Recall Bulletin

SUBJECT: Ignition Switch Replacement

MODELS: 2005-2007 Chevrolet Cobalt
2005-2006 Pontiac Pursuit (Canada Only)
2007 Pontiac G5

Part Number	Description	Quantity/Vehicle
23215459	Ignition and Start Switch	1

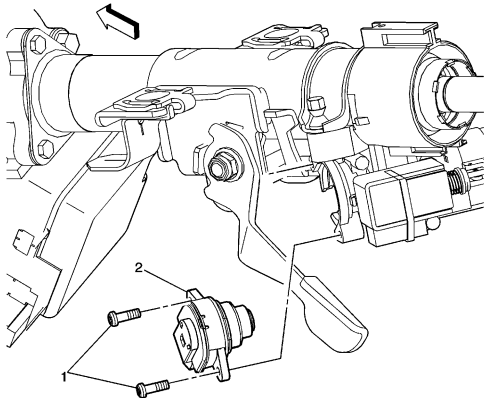
Dealers are to replace the ignition switch.

Note: GMCCA will utilize the VIN number provided on the ignition switch SPAC order to place an order on your behalf for the parts required for this recall as well as to complete safety recall 14113 or 14133, whichever is applicable. This will ensure alignment of the ignition switch shipment with the parts needed to complete all required recalls. You may receive the parts required for the repair as kit number 23232575 (Chevrolet branded keys) or kit number 23232576 (unbranded keys for Saturn or Pontiac vehicles). Each kit will contain an ignition switch, an ignition lock cylinder, two keys and two key rings.
